UBC Development Permit Board Meeting

Date: Wednesday, February 24, 2016

1. **That the Development Permit Board recommend that the Director, Campus and Community Planning issue a Development Permit for the market residential development on Lot 23 in Wesbrook Place Neighbourhood as detailed in the attached drawings (Attachment A), subject to the following conditions:**
 - 1) **That SC2-A.5 of the Development Handbook be relaxed for this project to permit reductions in minimum setback requirements at various locations for architectural roof and balcony projections.**

On January 7, 2016, Adera submitted a Development Permit application to Campus and Community Planning to develop a 6 storey market residential development with two levels of underground parking on Lot 23 in the Wesbrook Place Neighbourhood. The Wesbrook Neighbourhood Plan (Plan of Land Uses P-10) designates Lot 23 for up to 6 storeys of residential development with a maximum floor space ratio (FSR) of 2.8.

③ SUMMER, 2PM

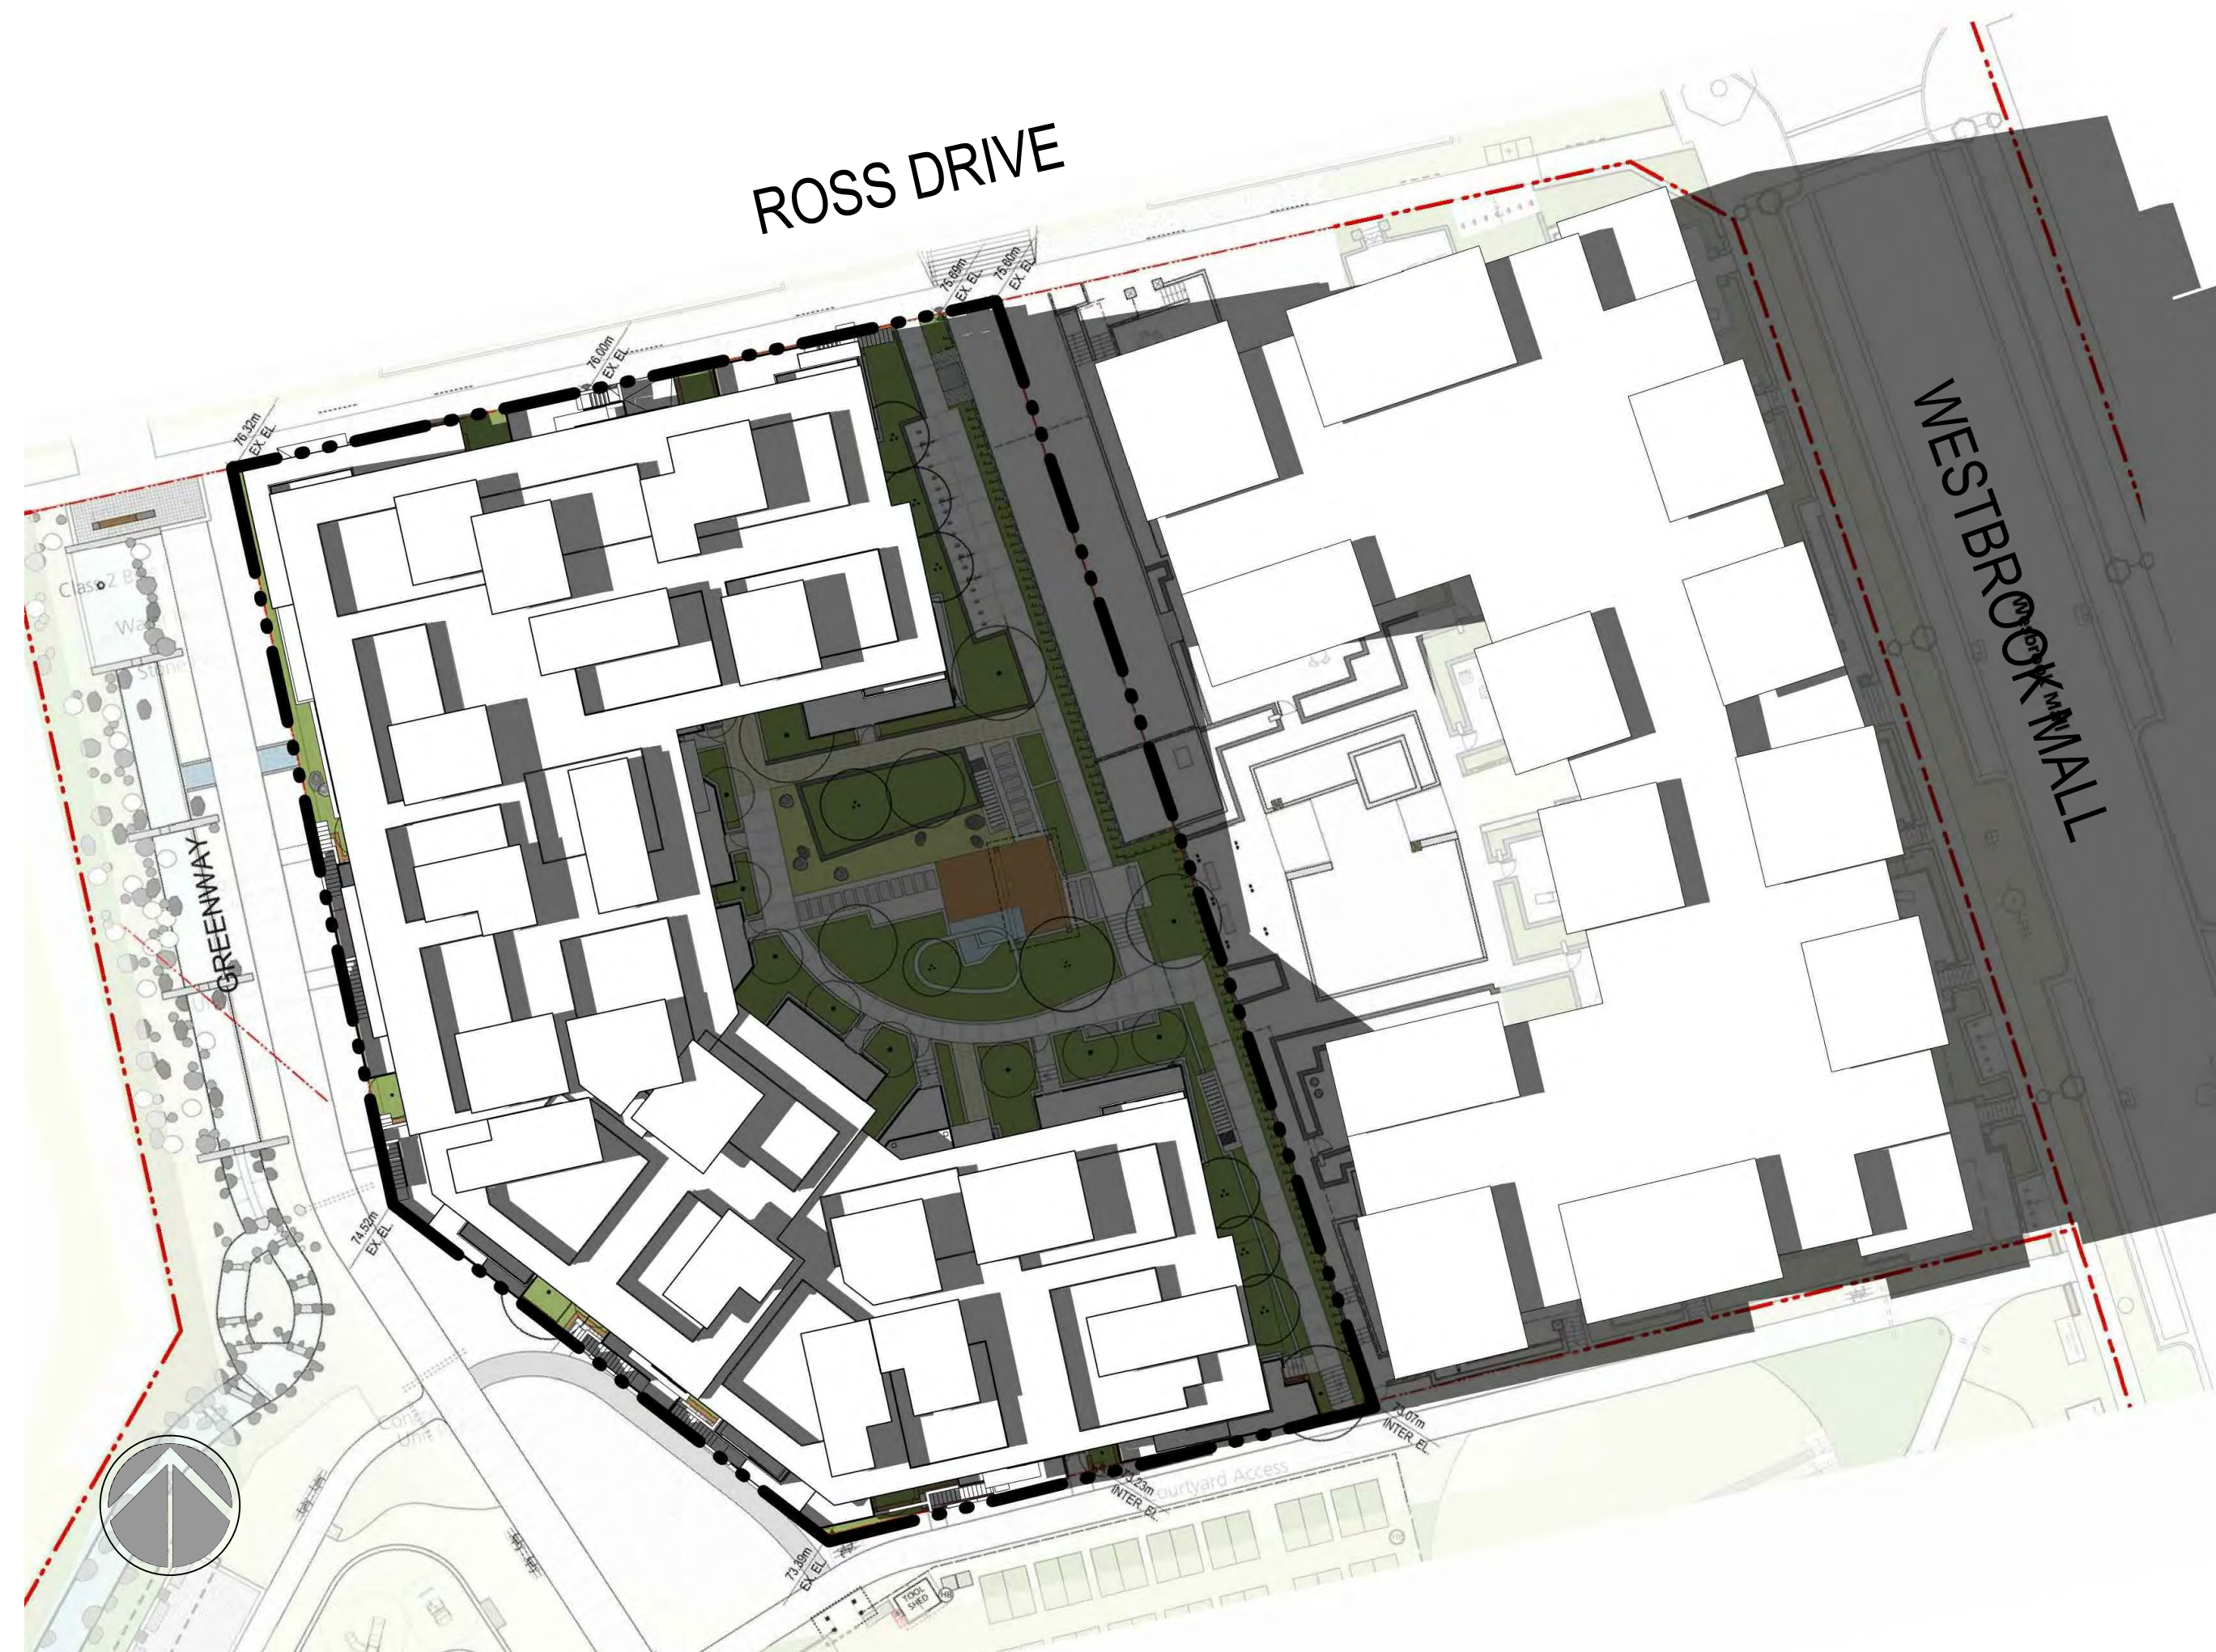
The Shadow study provided by the applicants on Sheets A6.6 and A6.7 in the plan set show the shadowing effects expected to be generated by combining the shadowing from each building on Lots 22 and 23. At the request of Campus and Community Planning, the shadowing study was expanded to include the shadows created by Nobel House as well as the new development in order to better understand cumulative impacts. In addition, shadow diagrams were prepared for four different timeslots instead of the previous three (10am, 12 noon, 2pm and 4pm).

The results of the shadow study show that while virtually all of the units in lots 22 and 23 will receive sun during the summer, portions of the courtyards will receive only partial sun. In the spring and fall, the courtyards in both projects will receive little or no sun and many of the west facing units in Nobel House will be in shade in early morning and late in the afternoon.

- **Shadow Diagrams**
- The shadow study was revised to include the shadow impacts of both Nobel House and the project buildings. The analysis was also expanded to include shadow diagrams in spring/fall and at four times of the day (10am, 12 noon, 2pm and 4pm).
